**CHANGE ORDER NO.: 2**

Description: Reed Bed Media Removal Payment, Driveway Revision, and Lift Station 3 Revision

Town of Bristol  
WWTP Improvements Project  
Change Order #2

**RE: Job Number S22145  
WWTP Improvement Project  
Proposed Change Order No. 2**

**EXISTING LIFT STATION  
NO 3. SITE  
IMPROVEMENTS PLAN  
(MA2)**

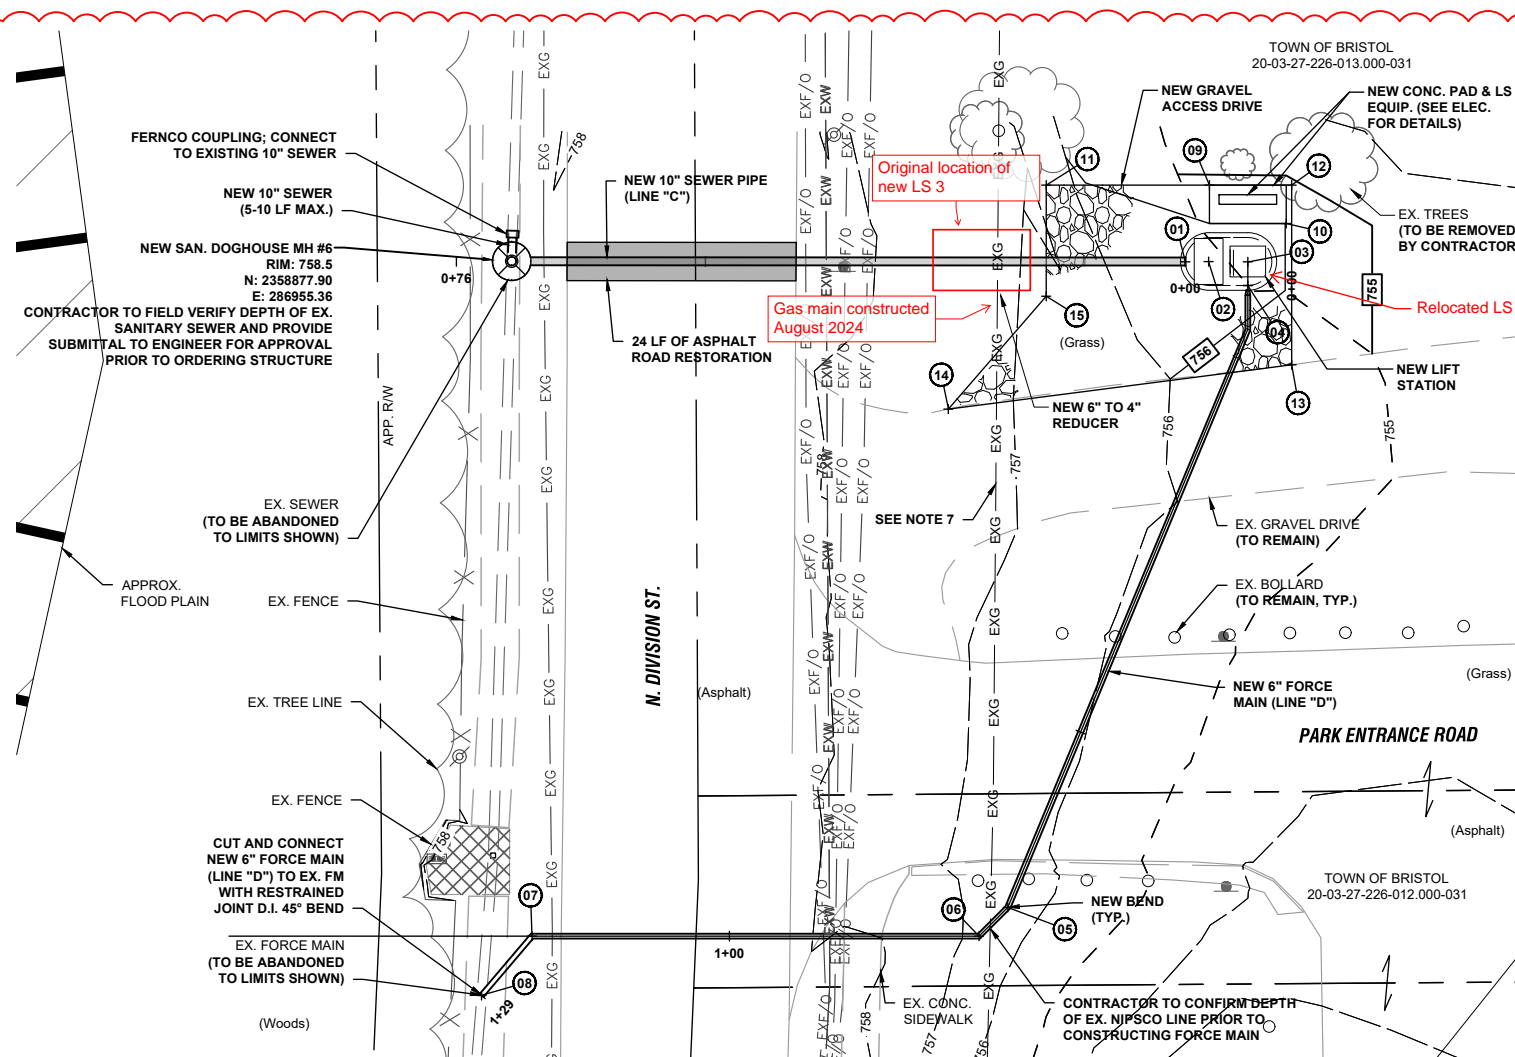
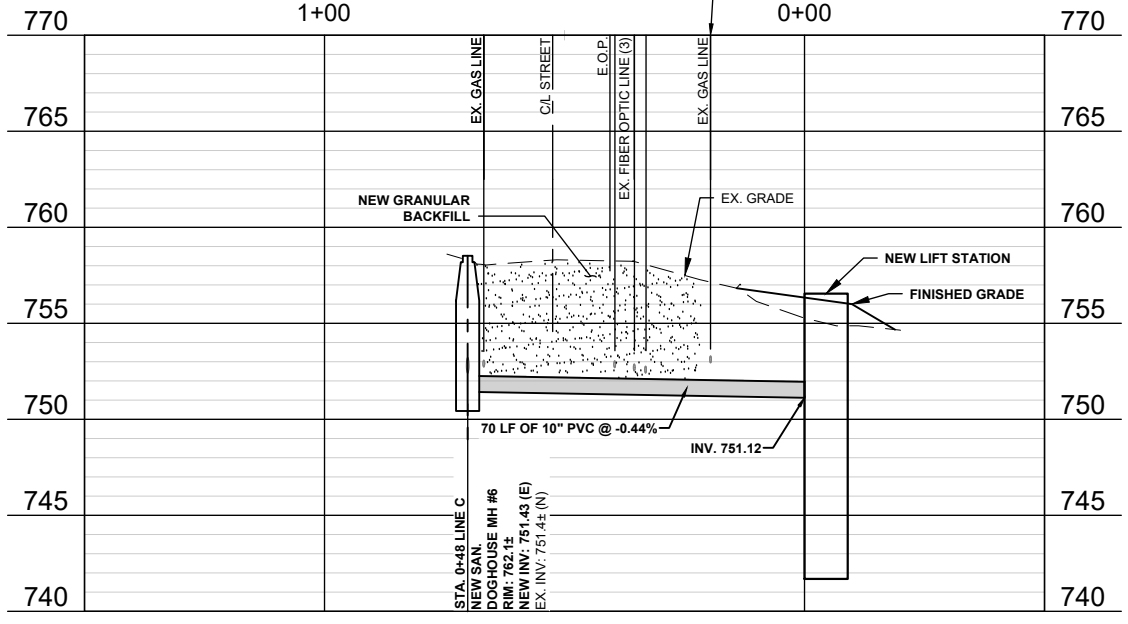
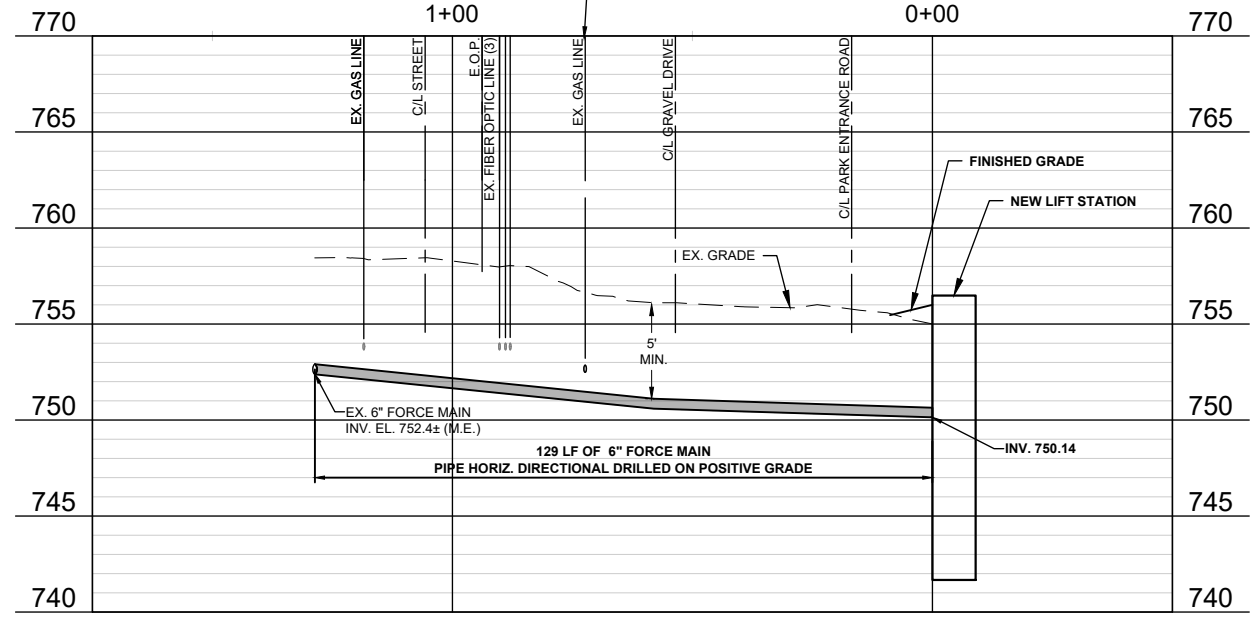
NIPSCO constructed a new gas main through the originally-planned location for relocated Lift Station 3. Engineer is shifting LS 3 further into the park to avoid this conflict.

The new location for Lift Station 3 is reflected in the attached plan sheets. Updated elevations for setpoints, incoming sewer invert, and outgoing forcemain invert and forcemain route are also included. The lift station overall depth and pump selection are not changing. There are existing trees near the new lift station location that are to be removed by the Contractor.

The approximate location of the new gas main is shown on the plans. Contractor shall locate the gas main prior to construction of the new sewer lines.

- APPROX. NIPSCO GAS MAIN LOCATION, TYP. DEPTH 32" TO 48", APPROX. 21 FT. FROM EDGE OF ROAD. CONTRACTOR TO CALL 811 AND LOCATE PRIOR TO CROSSING WITH NEW SEWER LINES.
